UNITED STATES PATENT AND TRADEMARK OFFICE

10/622,562

Office Action Summary	Application No. 10/622,562	Applicant(s) HO, PETER	
	Examiner NIHIR PATEL	Art Unit 3772

DETAILED ACTION

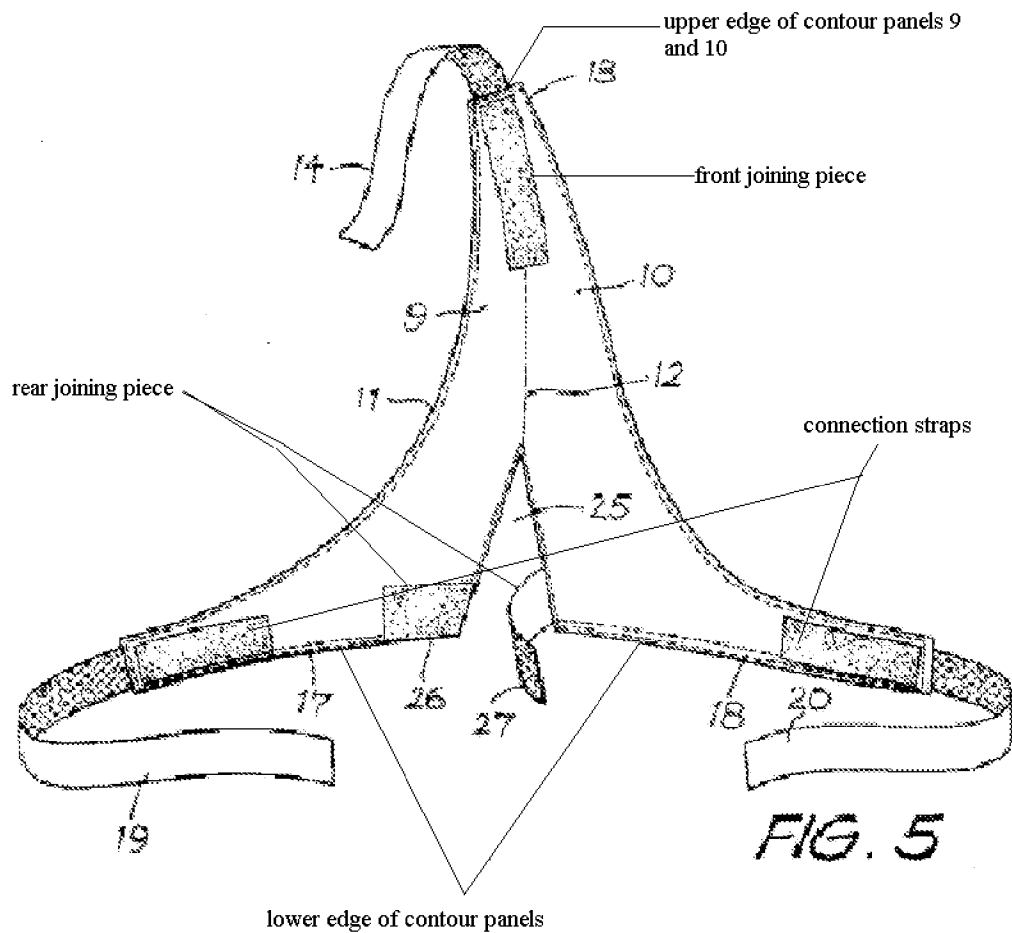
2. Applicant's arguments filed on May 4th, 2009 have been fully considered but they are not persuasive. The applicant argues that Lomas does not disclose "a plurality of contoured panels... wherein each contoured panel the length of the upper edge is shorter than the length of the lower edge,"; "a rear joining piece positionable along a rear portion of a patient's head, wherein the lower edge of each contoured panel is connected to the rear joining piece, and a front joining piece positionable along a front portion of such a patient head, wherein the upper edge of each contoured panel is connected to the front joining piece" and "wherein the connecting strap extends from either the rear joining piece or the front joining piece. The examiner disagrees with the applicant's argument (See figure 5 below).

As shown in the above figure 5 of the Lomas reference, Lomas does disclose “a plurality of contoured panels... wherein each contoured panel the length of the upper edge is shorter than the length of the lower edge,”; “a rear joining piece positionable along a rear portion of a patient’s head, wherein the lower edge of each contoured panel is connected to the rear joining piece, and a front joining piece positionable along a front portion of such a patient head, wherein the upper edge of each contoured panel is connected to the front joining piece” and “wherein the connecting strap extends from either the rear joining piece or the front joining piece.

6. **As to claims 13 and 21**, Lomas teaches an apparatus that comprises a patient interface device **1 (see fig. 2; col. 2 lines 20-30)** adapted to fit over a portion of a patient and having a connector element; a headpiece **8 (see fig. 2)**; and a connecting strap **19 and 20 (see figs. 5 and 6)** attached to the headpiece and adapted to releasably connect the headgear to the connector element **(see fig. 2)**; wherein the headpiece comprise a plurality contoured panels **(see fig. 5 above)**, each panel including an upper edge having a length and a lower edge having a length **(see fig. 5 above)**, wherein each contoured panel the length of the upper edge is shorter than the length of the lower edge **(see fig. 5 above)**; a rear joining piece positionable along a rear portion of a patient's head **(see fig. 2 and fig. 5 above)**; wherein the lower edge of each contoured panel is connected to the rear joining piece **(see fig. 2 and fig. 5 above)**; and a front joining piece positionable along a front portion of such a patient's head **(see fig. 2 and fig. 5 above)**, wherein

the upper edge of each contoured panel is connected to the front joining piece (**see fig. 2 and fig. 5 above**), wherein the connecting strap extends from either the rear joining piece or the front joining piece (**inherently connecting straps are connected to the rear joining piece because they both have to interact with each other**).

7. **As to claims 14 and 26**, Lomas teaches an apparatus wherein the connecting strap **14** is an upper connecting strap attached to the front joining piece and adapted to releasably connect the headgear to the patient interface device (**strap 14 can also be defined as connecting strap; see figs. 2 and 5 above**).

8. **As to claims 15 and 27**, Lomas teaches an apparatus that further comprises a lower connecting strap attached to the rear joining piece and adapted to releasably connect the headgear to the patient interface device (**see fig. 2 and fig. 5 above**).

14. **As to claims 25 and 33**, Lomas teaches an apparatus that comprises a gas flow generating device that produces a flow of gas (**see figure 2**); a conduit having a first end portion operatively coupled to the gas flow generating device and a second end portion (**see figure 2**), wherein the conduit carries the flow of gas from the gas flow generating device during operation of the system; a patient interface device **1** (**see fig. 2; col. 2 lines 20-30**) coupled to the second end portion of the conduit; the patient interface device having a connector element; and a headgear comprising a headpiece **8**; and a connecting strap **14, 19 and 20** (**see fig. 2 and fig. 5 above**) attached to the headpiece and adapted to releasably connect the headgear to the connector element (**see figure 2**); wherein the headpiece comprises a rear joining piece positionable along a rear portion of a patient's head (**see fig. 2 and fig. 5 above**); and a front joining piece positionable along a front portion of such a patient's head (**see figure 2 and fig. 5 above**), and a first contoured panel **9** and a second contoured panel **10**, wherein each of the first and second contoured panels extend from the rear joining piece to the front joining piece (**see fig. 2 and fig. 5 above**), each of the first and second contoured panels including an upper edge having a length and a lower edge having a length, wherein each of the first and second contoured panels the length of the upper edge is shorter than the length of the lower edge (**see fig. 2 and fig. 5 above**) and wherein each lower edge is connected to the rear joining panel and each upper edge is

connected to the front joining panel, wherein the connecting strap extends from either the rear joining piece or the front joining piece (**see fig. 2 and fig. 5 above**).
